SCAGI - Seymour Community Action Group Inc.

Re: Objection to the granting of a works permit for an instream dam at Unnamed Tributary of Doctors Creek.

Attachment: Appendix A

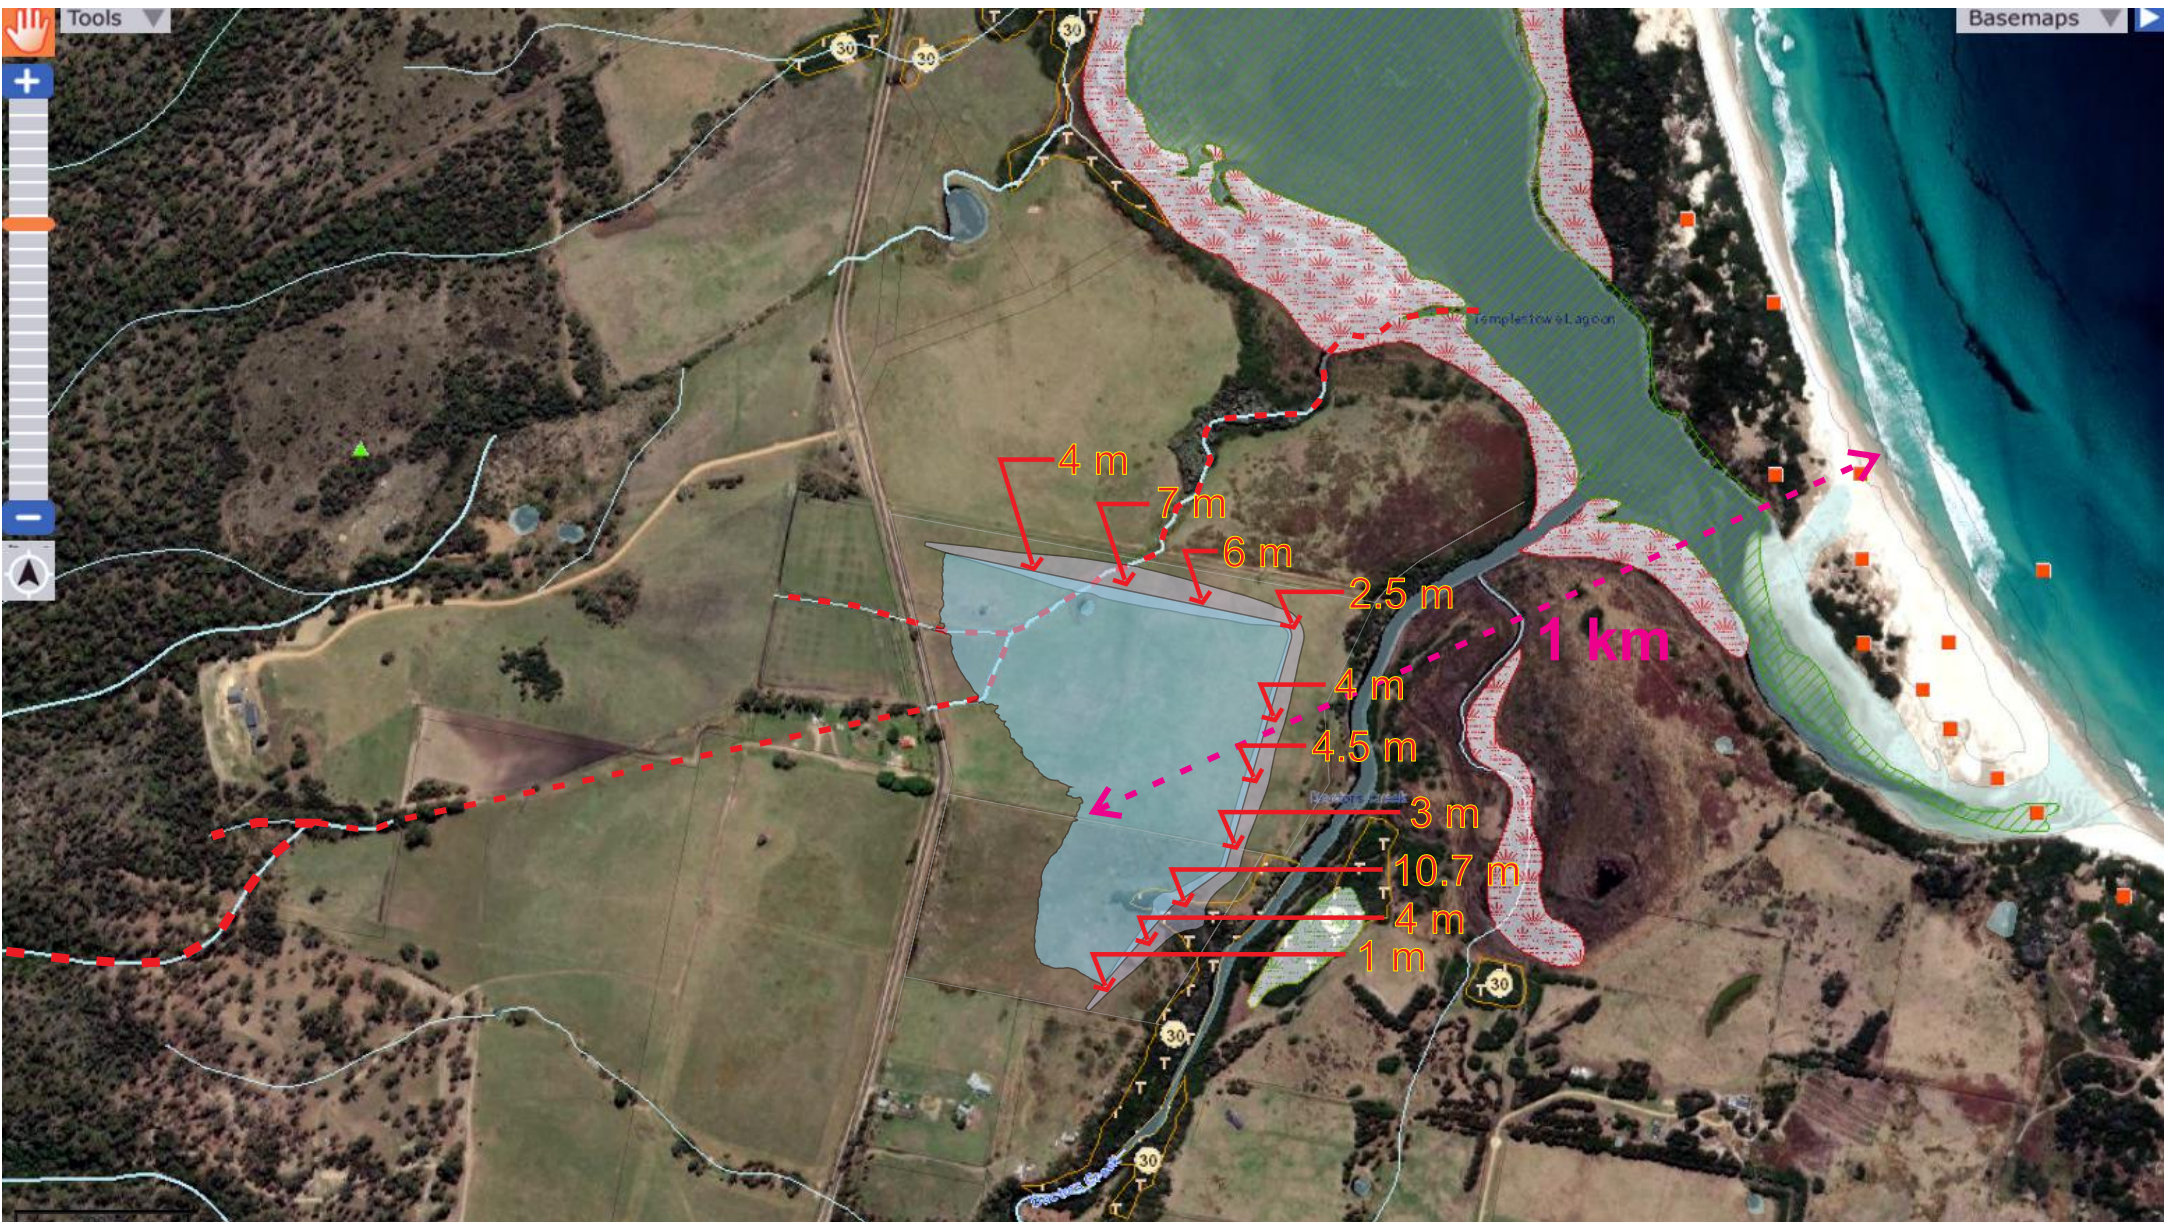
- The proposed dam is not instream of the Unnamed Tributary of Doctors Creek but is in fact a freshwater tributary to Templestowe Lagoon. This is in error throughout the whole of the application documents. Templestowe Lagoon has a CFEV Estuaries – Integrated Conservation Value of: High.

- The advertised height of the dam wall is not 9.8 m but in fact 10.7 m according to the survey plan. The Dam Works Assessment Decision Framework reads: the maximum height means the height from the crest of the dam to the lowest point of natural ground level.

- Coastal Zone - Framework Item 5.6 - The Coastal Zone is defined in the Water Management (Division 3 Declared Works) Order 2015 as all State waters, within the meaning of the Living Marine Resources Management Act 1995; and all land to a distance of one kilometre inland from the high-water mark. The Dam is clearly within 1km inland and therefore within the Coastal Zone.
- The information below is missing in the application.

Coastal Zone / Dam wall heights from crest to lowest natural ground level
